Interactive comment on “Quantifying alkane emissions in the Eagle Ford Shale using boundary layer enhancement” by G. Roest and G. Schade

The authors' responses to Anonymous Referee #1 are below. Each response is provided below the Referee's original comments.

Fig. 1. Figure 1 in the manuscript has been updated to address the Referee's first comment.

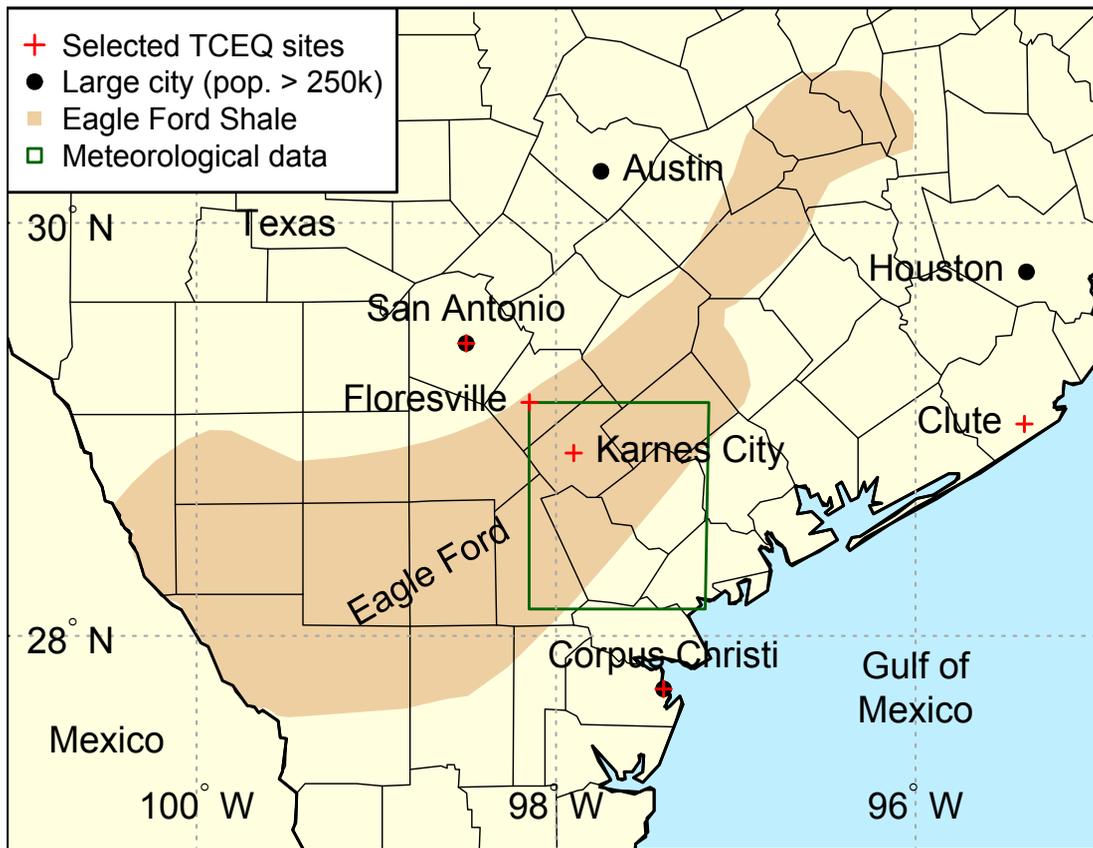
"Section 2.1: I had a hard time figuring out how many sites were used in the analysis based on the description in Section 2.1 and Figure 1. Table S1 was helpful for me to understand - consider moving it to the main paper. Indicate that there are five total sites. Section 2.1 says there are "several sites in Corpus Christi, including Hillcrest and Oak Park" but only those two are indicated in Table S1. I would also use a different color and/or more prominent symbol for the TCEQ sites in Figure 1 - as it is the symbols are hard to find, especially ones inside the circles indicating large cities."

Response: Table S1 has been moved to the main text as Table 1 and the selection of the two sites in Corpus Christi has been justified. Figure 1 has also been updated and is attached.
